Access Compliance Report Public Rights-of-Way (Curb Ramps)

Main Street: WINDMILL_AVE Cross Street: ANTONIO_PKWY Location: N

ADA ID: RPRK211029140012 Ramp Type: Type 1 - Perpendicular Diagonal Initial Pass/Fail: Fail Overall Compliance: No Severity Score: 2

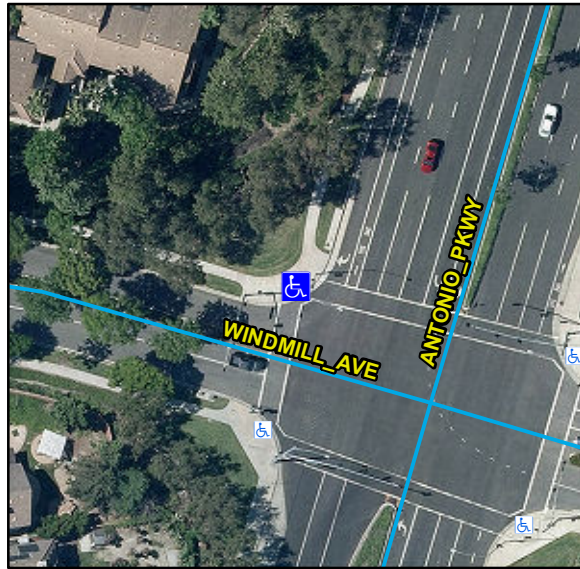
Compliance	Description	Data	Compliance	Description	Data
N/A	Ramp Length (in)	105	N/A	Flare Type LT	
Yes	Ramp Width (in)	48			N/A
Yes	Ramp Run Slope (%)	5.6	N/A	Flare Slope LT (%)	N/A
No	Ramp Cross Slope (%)	3.4	N/A	Flare Traversable LT	N/A
N/A	Landing Present	N/A	N/A	Flare Type RT	
N/A	Landing Length (in)	N/A			N/A
N/A	Landing Width (in)	N/A	N/A	Flare Slope RT (%)	N/A
N/A	Landing Run Slope (%)	N/A	N/A	Flare Traversable RT	N/A
N/A	Landing Cross Slope (%)	N/A	N/A	DWS Provided	N/A
N/A	Landing Movement Obstructed?	N/A	N/A	DWS Contrast	N/A
	Landing Movement Type	N/A	N/A	DWS Length (in)	N/A
N/A	Landing Shared	N/A	N/A	DWS Full Width	N/A
N/A	Clear Space	Yes	N/A	DWS Offset Left (in)	N/A
N/A	Clear Space To Crosswalk (in)	48	N/A	DWS Offset Right (in)	N/A
N/A	Marked Crosswalk 1	Yes	N/A	Marked Crosswalk 2	Yes
	Crossing 1 Direction	SW		Crossing 2 Direction	SE
	Marked Crosswalk 1 Width (in)	110		Marked Crosswalk 2 Width (in)	110

N/A	Ramp Inside Crosswalk 1	Yes	Yes	Ramp Inside Crosswalk 2	Yes
	Crossing 1 Slope (%)	3.1		Crossing 2 Slope (%)	6.2
	Crossing 1 Cross Slope (%)	2.6		Crossing 2 Cross Slope (%)	4.3
N/A	Gutter Ponding	N/A	No	Curb Slope	10.2
Yes	Gutter Lip Height (in)	0		Road Run Slope (%)	3.2
N/A	Gutter Run Slope (%)	N/A		Road Cross Slope (%)	1.8
N/A	Gutter Cross Slope (%)	N/A			
Yes	Overall Surface Condition: Acceptable		No	Perp Joint Present	No
	Cross Gutter Present?	No		Spandrel Present?	No
	Replace Cross Gutter?	N/A		Replace Spandrel?	N/A

Remove & Replace Curb Ramp With Two New Directional Ramps or Equivalent.

R304.2.2, R204.3, R304.5.3, STD 1115
